re: Preliminary Geotechnical Review - Proposed SWMP
Proposed Residential Development
Cardinal Creek Village South – Ottawa, Ontario

to: Taggart Investments - **Ms. Michelle Taggart** - mtaggart@taggart.ca
to: HP Urban Inc. - **Mr. Peter Hume** - peter.hume@hpurban.ca
to: DSEL - **Mr. Braden Kaminski** - Bkaminski@dsel.ca
date: December 2, 2022
file: PG5201-MEMO.01 Revision 2

POND OUTLET SECTION
N.T.S.

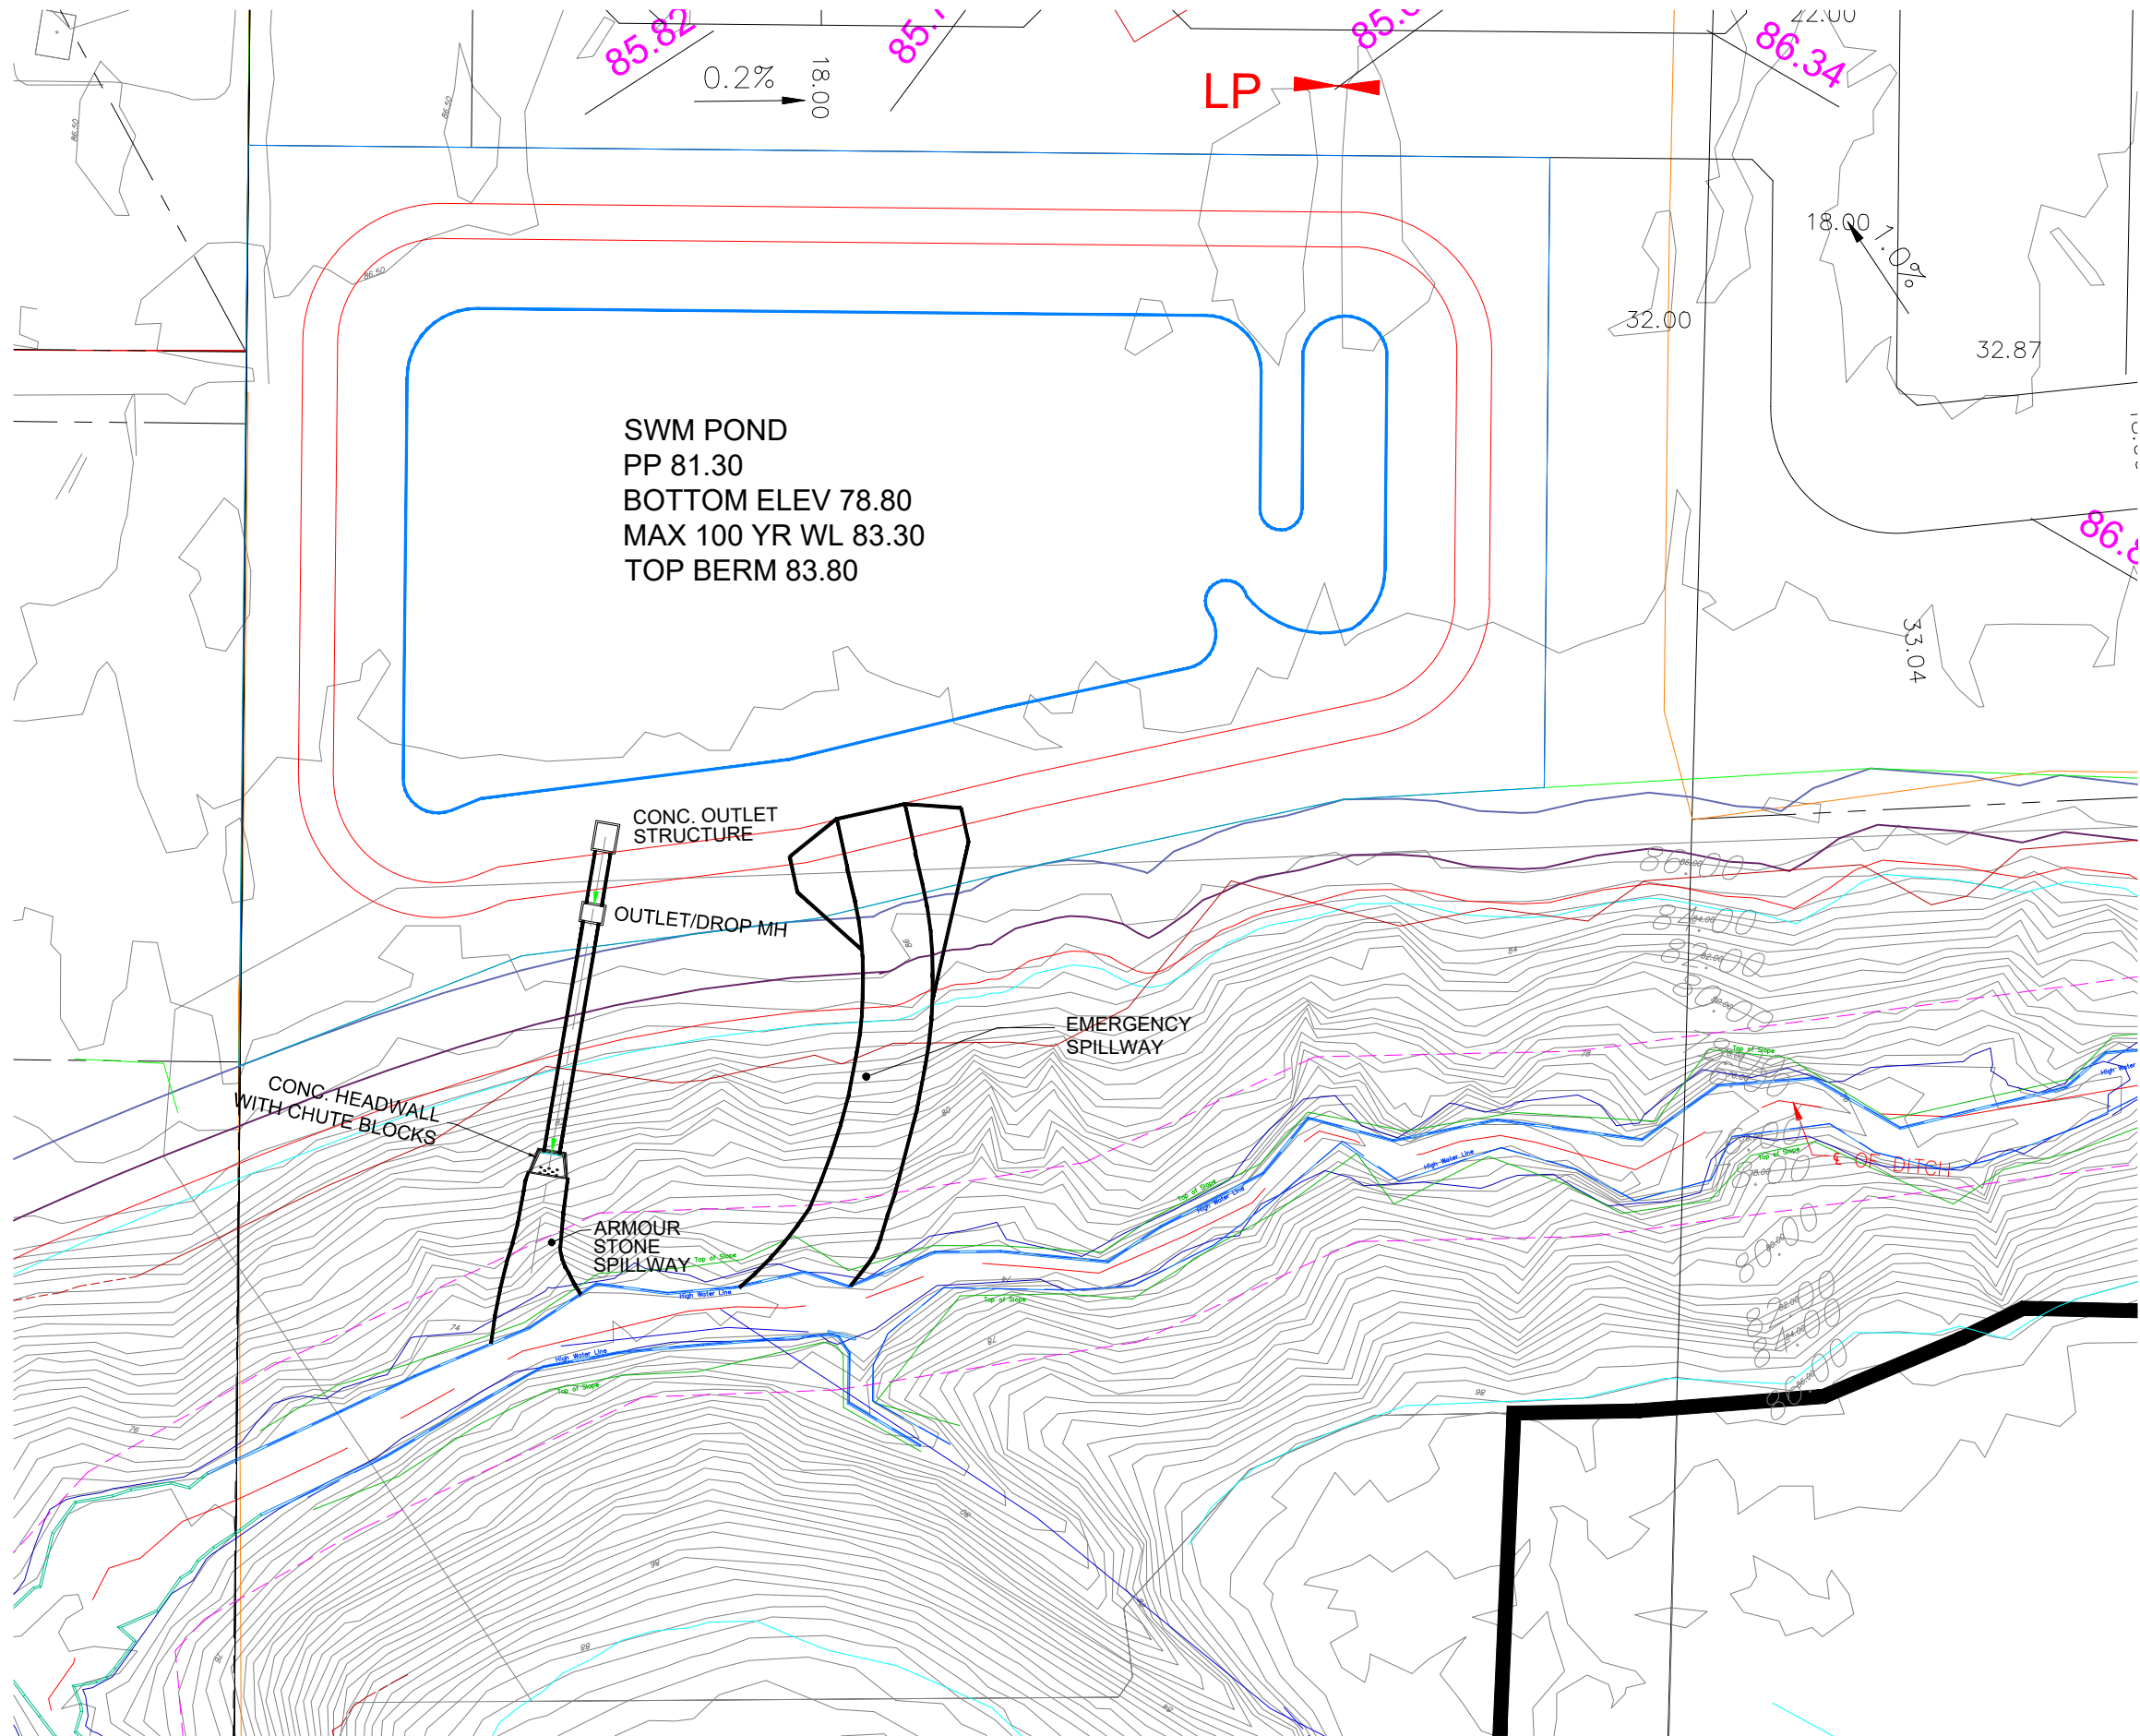
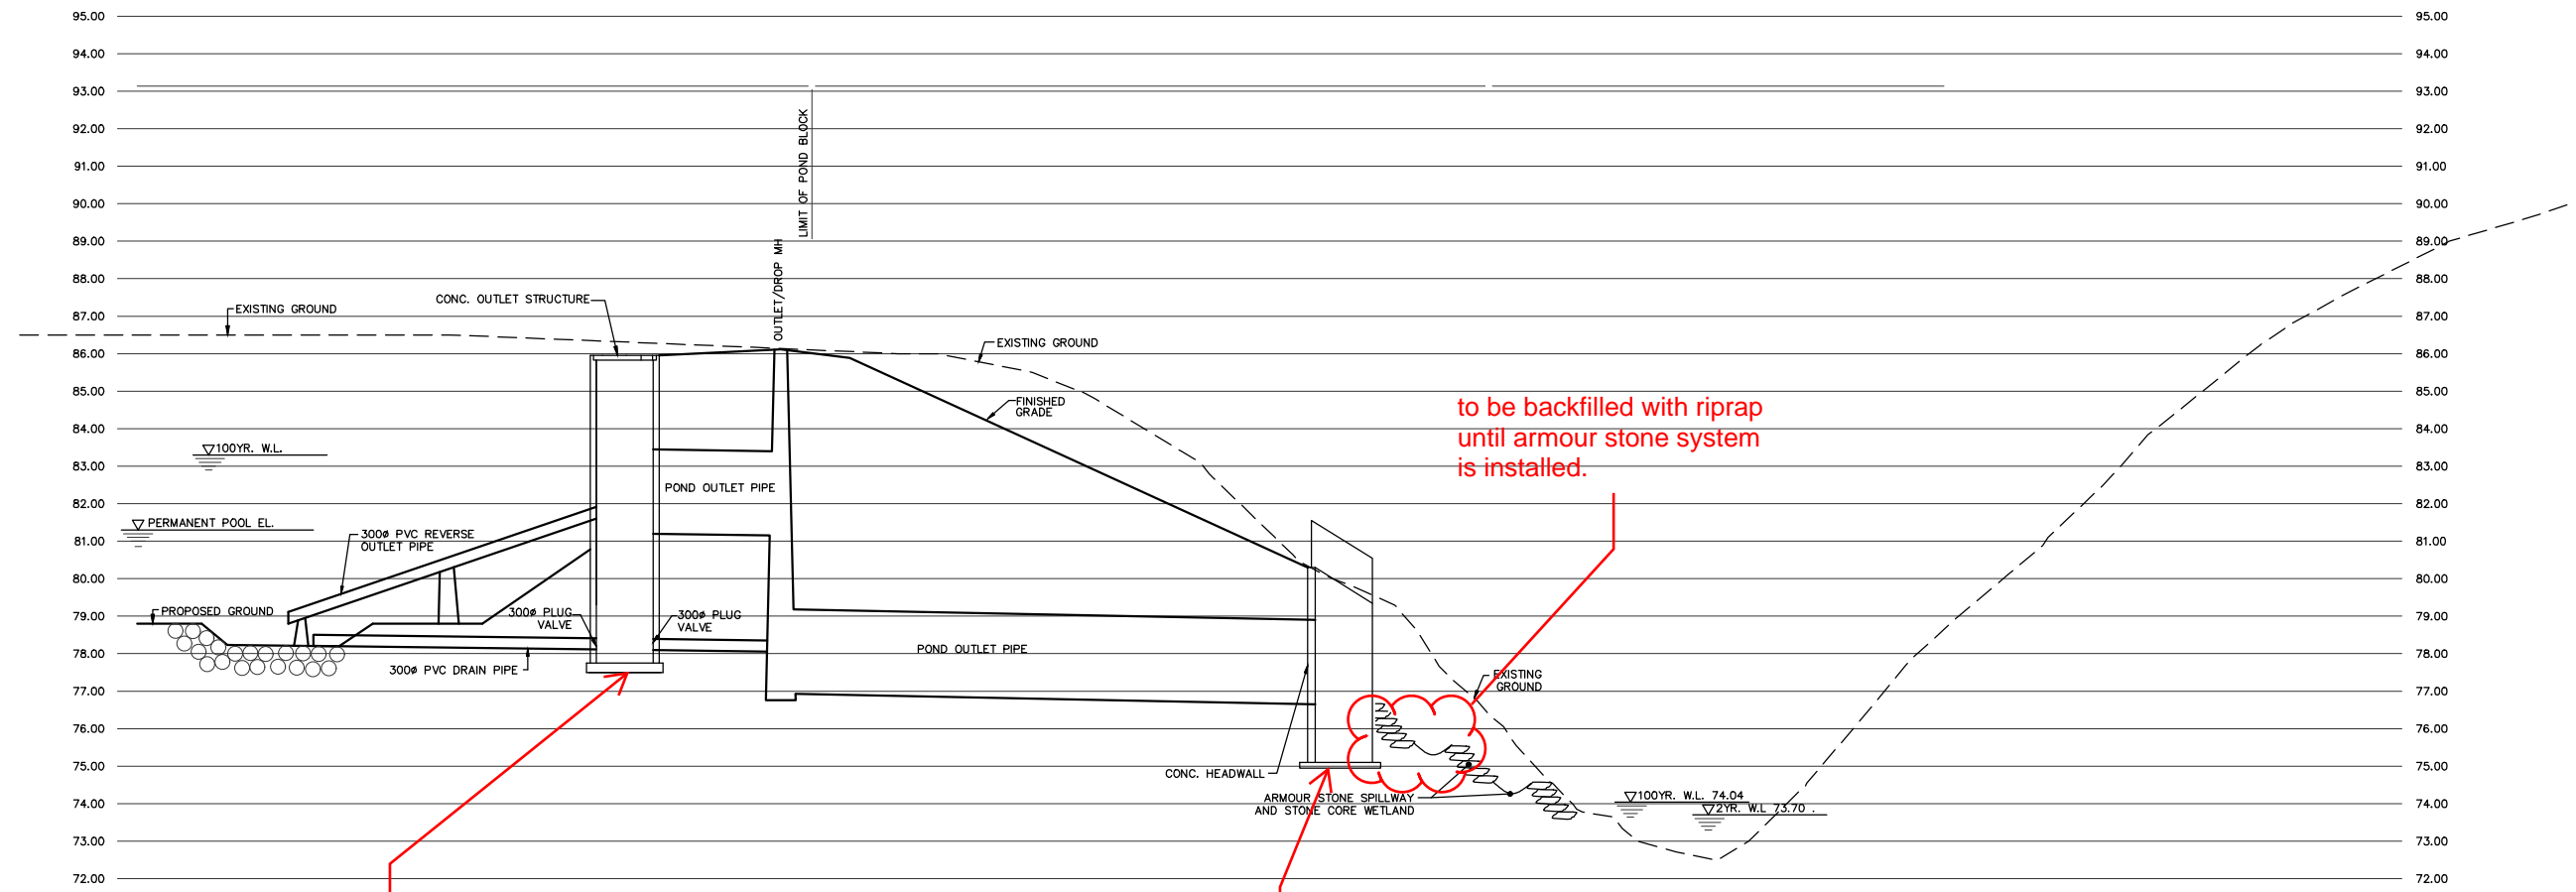
Paterson Notes: Bearing medium expected to be Stiff Grey Silty Clay and/or Glacial till.

Paterson Notes: Bearing medium expected to be glacial till over bedrock and/or bedrock.

to be backfilled with riprap until armour stone system is installed.

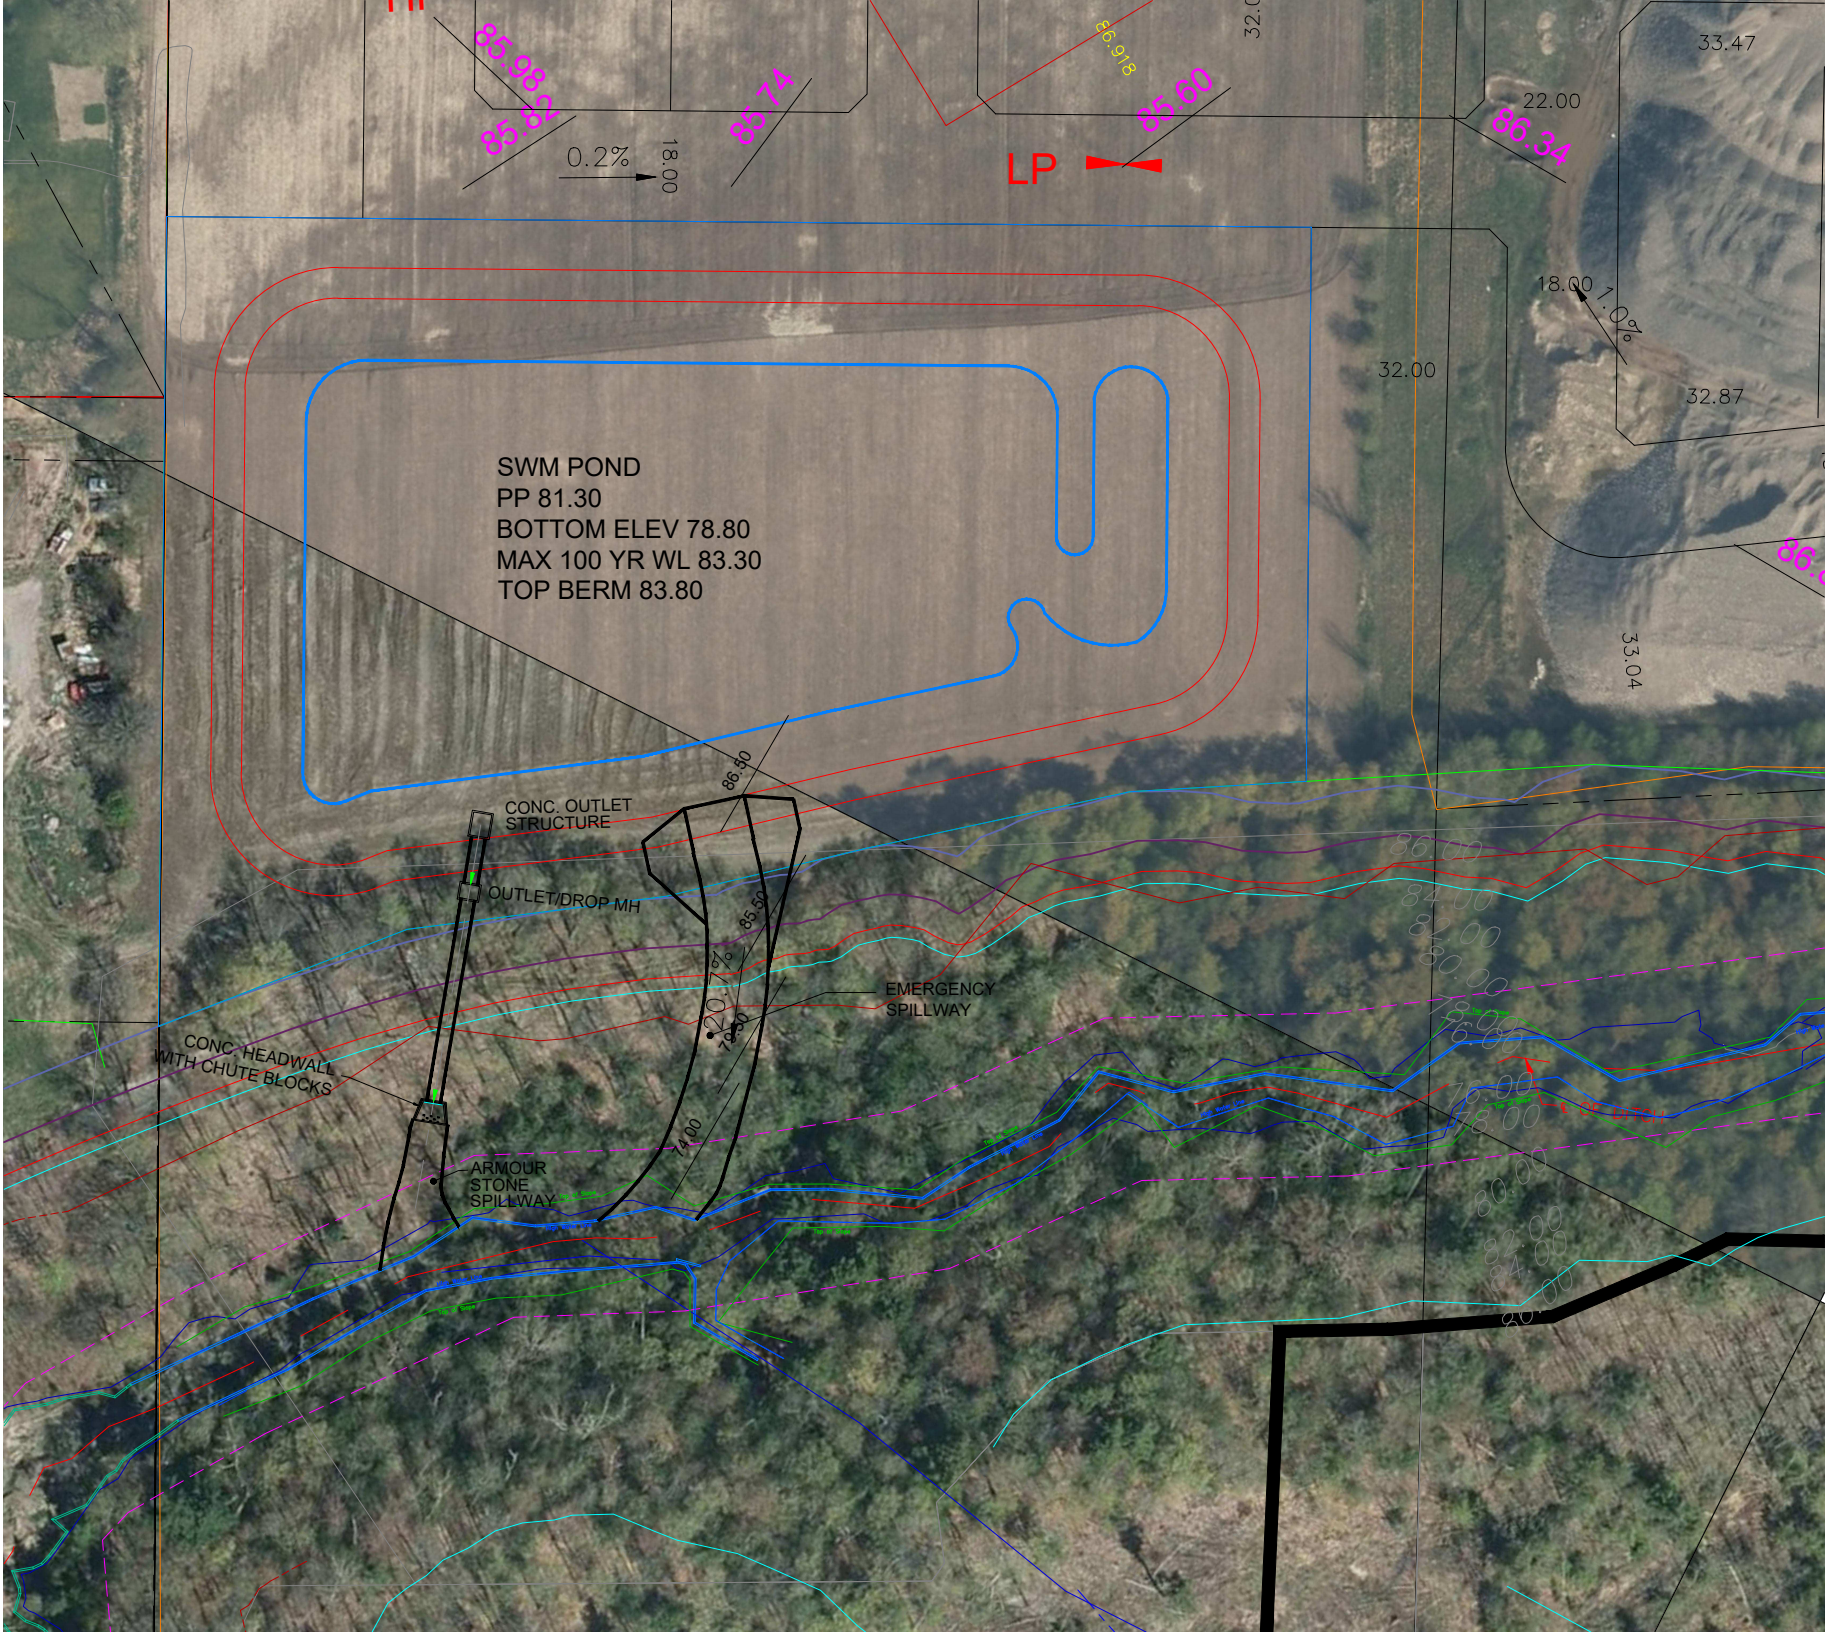
Paterson reviewed the current preliminary design drawings for the SWMP outlet structure (attached to the end of this memo). Based on our review, the proposed concrete headwall and outlet structures will be founded on Stiff grey silty clay and/or inferred glacial till. The bearing resistance values for the proposed structures can be taken from the "bearing capacity for concrete structures" section in the previous page.

The Spillway fronting the pond outlet pipe is proposed to be terraced with armour stone blocks. It is recommended that the armour stone blocks be placed on a sufficient bearing medium. The bearing medium should be cut back in a stepped fashion down to the edge of the Cardinal Creek stream. If bedrock is encountered at the bottom of excavation, bedrock removal may be required to accommodate the stepped subgrade recommended herein. Each step should be cut a minimum 1.2 m horizontally and maximum 0.6 m vertically. If soil is encountered at the steps, a non-woven geotextile liner such as Terrafix 270R or equivalent, should be used to cover the subgrade. The subgrade should be built up to the underside of the armour stone using OPSS Granular A crushed stone or Granular B Type II placed in maximum 300 mm thick loose lifts and compacted to a minimum 98% of the material's SPMDD.

The armour stone blocks should be backfilled with engineered fill such as OPSS Granular A or Granular B Type II compacted to a minimum 95% of the material's SPMDD. The armour stone blocks should be placed staggered in a Piano-key fashion and battered at a minimum 100 mm between rows to enhance the overall global stability of the system. Due to the nature of armour stone blocks, the blocks will be in different sizes and shapes and may form voids between the blocks. Therefore, it is recommended that non-woven geotextile liners such as Terrafix 270R or equivalent, be placed between the armour stone blocks and the backfill material to prevent the loss of the backfill material.

If the bottom concrete headwall is founded over silty clay or glacial till, it is highly recommended that riprap stone be placed against the bottom of the headwall structure to prevent the running water from undermining the headwall footings until the armour stone wall system is constructed. The riprap stone should consist of stone fragmented to maximum size of 400 mm with sharp edges to allow for interlocking between the riprap material.
